**From:** James Aronoff <james@canopypdx.com>  
**Sent:** Friday, March 14, 2025 9:57 AM  
**To:** Nick Turrell; Wendy Fan; Jason Karam; Ben Anderson  
**Subject:** Nail Pile adjustment  
**Attachments:** Canby Street - Lot 21 - Slope Stability.pdf; 2025-02-04\_25036 - Canby Site 21 Modifications Drawings R4 (dragged).pdf

To:	Wendy Fan Process Architecture	From:	Jared Fischer, PE – Principal Waypoint Engineering, Inc.
Project Name:	Canby Site 21	Project Number:	25036
Subject:	Pile Removal Memo	Date:	April 1, 2025

Permit #: 24-045962-REV-01-RS

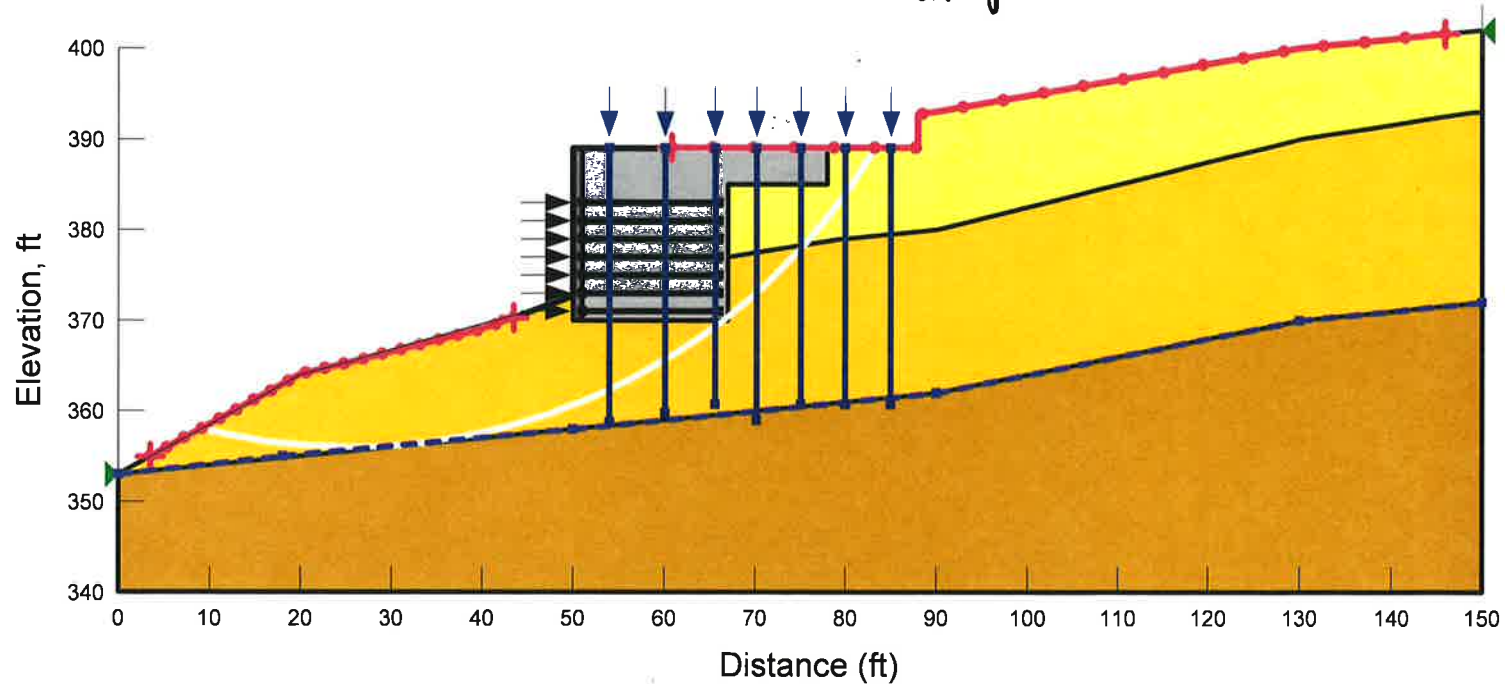
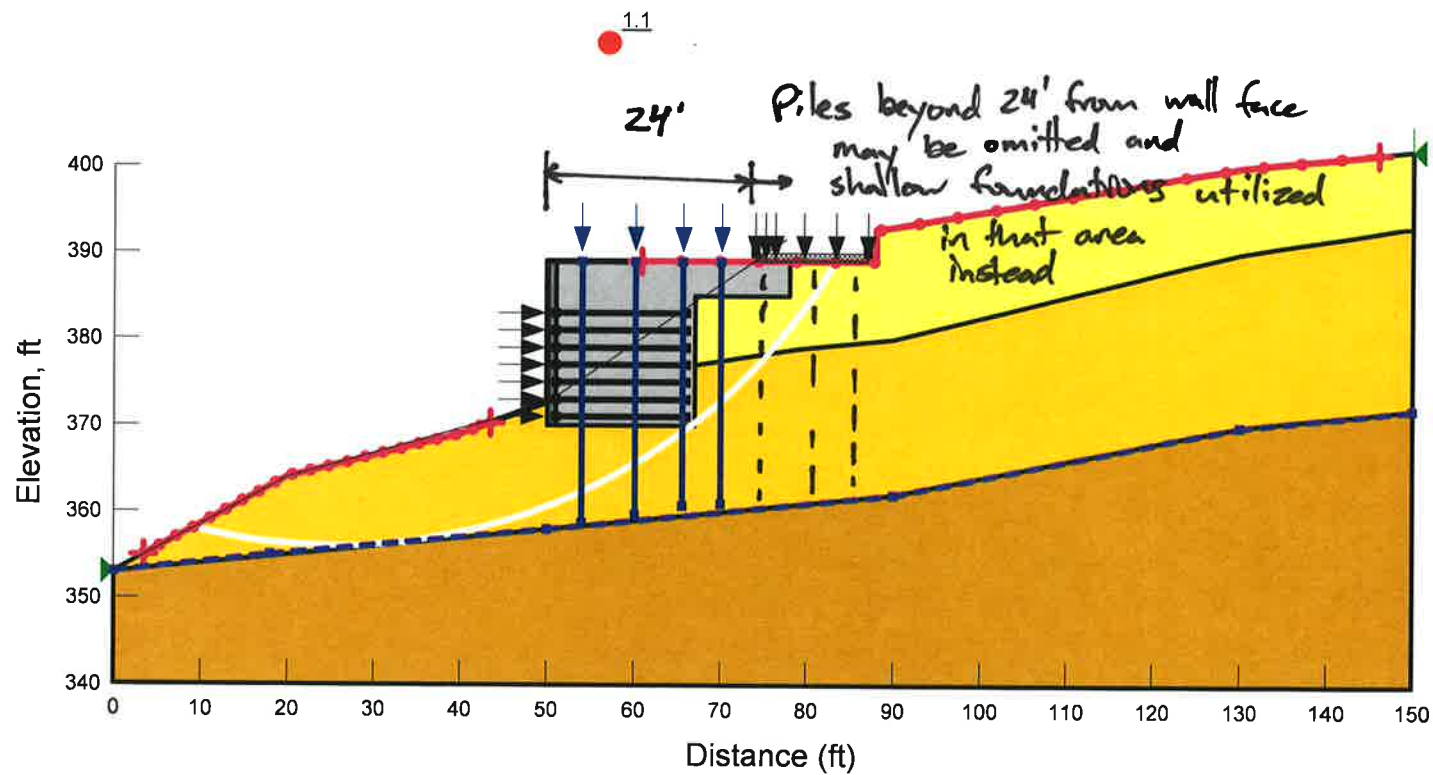
I was discussing with Ben Andersen, and he gave me approval to remove any nail pile, 24ft away from the face of the wall, as long as the structural engineer is ok with it. Attached is an email and calculation showing his approval

I did some calculations. If the structural is ok with it, the portion of the house farther than 24 feet away (horizontally) from the wall face can be supported by conventional shallow foundations instead of the driven piles. There may be about 1/8-inch of differential settlement between the part of the house on piles and the part of the house on conventional shallow foundations.

Current  
 Original recommendation is to  
 support entire foundation on  
 driven piles

Waypoint Engineering, Inc. was retained by Process Architecture to provide structural engineering design for Canby Site 21. After the initial design with piles supporting the entire perimeter foundation the Geotechnical engineer provided slope stability analysis stating that piles were not required when the supporting element was within 24 feet of adjacent site retaining wall. Waypoint Engineering have provided updated structural drawings dated March 28<sup>th</sup>, 2025 with the piles removed. Based on our engineering judgement and professional opinion, removing the piles at the location stated above will not hinder the structural integrity.
